NVM Express® Technical Proposal (TP)

Technical Proposal ID	6038 Management Interface Miscellaneous Maintenance
Revision Date	2024.07.28
Builds on Specification(s)	NVM Express Management Interface Specification, Revision 1.2d NVM Express Base Specification, Revision 2.0d
References	ECN116 ECN120 TP4029a Power Loss Signal Support TP6027b Reset Behavior Enhancements TP6033a MCTP Packet Timing TP6035a Out-of-Band Asynchronous Events

Technical Proposal Overview

Figure TBD2 Operational Time Example Timing Diagram

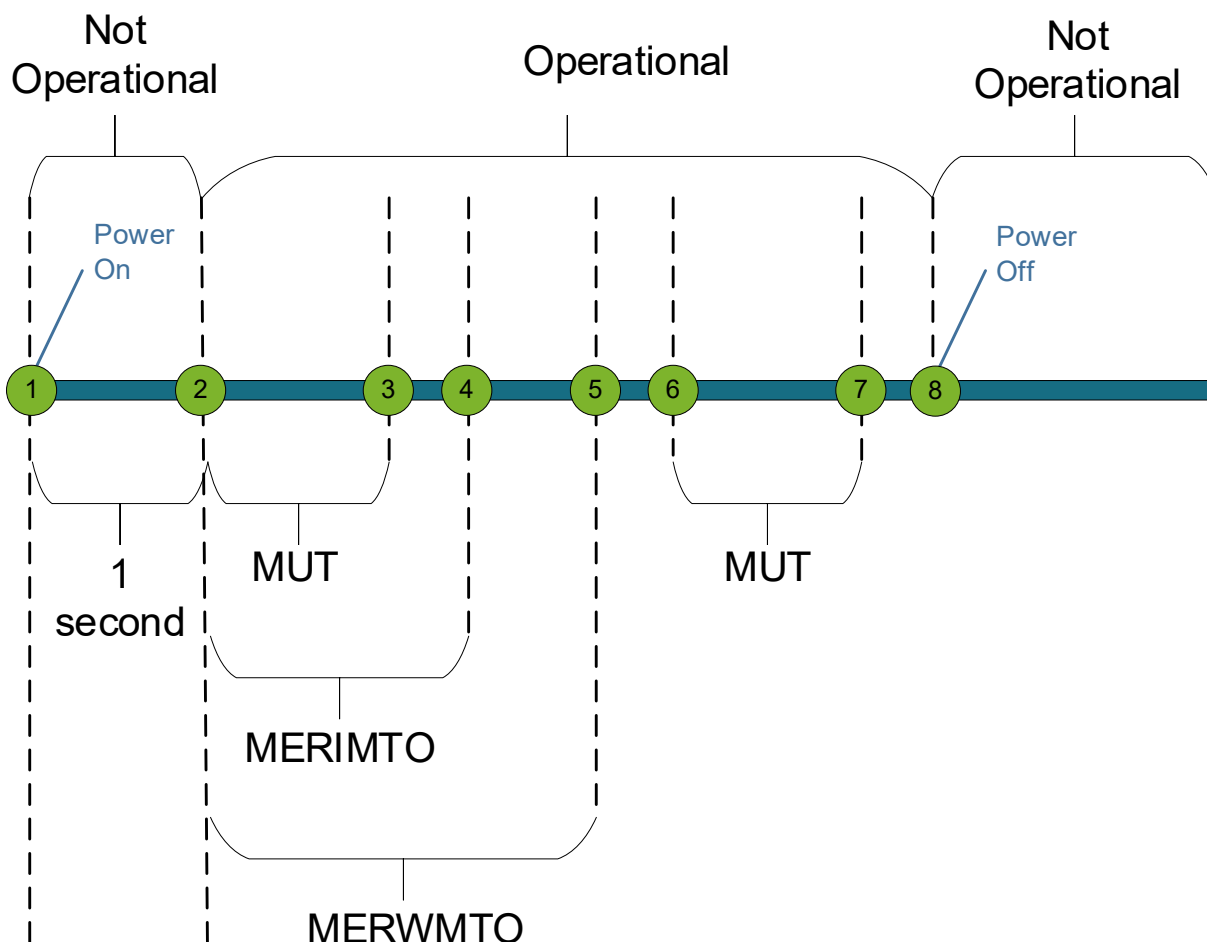
An example operational timing diagram is shown in [Figure TBD2](#). In this example, there are no shutdowns of any Controller or of the NVM Subsystem. And in this example, the value in the MUT field is smaller than the value in the MERIMTO field which is smaller than the value in the MERWMTTO field, but this ordering is not required. The sequence of events in [Figure TBD2](#) is as follows:

1. The NVM Subsystem transitions from a power state in which accesses to a Management Endpoint, FRU Information Device, and/or SMBus/I2C Mux are not supported to one where accesses are supported. After entering the power state in which accesses are supported, any Management Endpoint, FRU Information Device, or SMBus/I2C Mux in the NVM Subsystem is permitted to be non-operational for a maximum time of 1 s. While non-operational, none of the operations in [Figure 147](#) are supported and if a Management Controller performs any of those operations, then the results are undefined.

2. Within 1 s after transitioning from a power state in which accesses are not supported to one where accesses are supported, SMBus/I2C VPD and SMBus/I2C Mux accesses are processed, unless otherwise specified, and MCTP accesses should be processed.

- 3. Within the amount of time indicated by the MUT field since entering the operational state, the Management Endpoint is no longer permitted to be unresponsive to MCTP accesses.

- 4. Within the amount of time indicated by the MERIMTO field since entering the operational state, the Management Endpoint is ready to process Request Messages that do not require access to media.

- 5. Within the amount of time indicated by the MERWMTO field since entering the operational state, the Management Endpoint is ready to process Request Messages that require access to media.

- 6. While operational, if the Management Endpoint is unresponsive and unable to service a Request Message or return any Response Message, including a More Processing Required Response Message (e.g., due to activating a firmware image without reset), then the Management Endpoint discards any received Request Messages. While operational, if SMBus/I2C VPD accesses or SMBus/I2C Mux accesses are not supported, then the SMBus/I2C VPD accesses or SMBus/I2C Mux accesses are NACKed.

- 7. While operational, the Management Endpoint is unresponsive to MCTP accesses, SMBus/I2C VPD accesses, and SMBus/I2C Mux accesses for no longer than the amount of time indicated by the MUT field.

- 8. The NVM Subsystem transitions from a power state in which accesses to a Management Endpoint, FRU Information Device, and/or SMBus/I2C Mux are supported to one where accesses are not supported. The behavior of any access from the Management Controller that is not supported in the current power state is undefined.
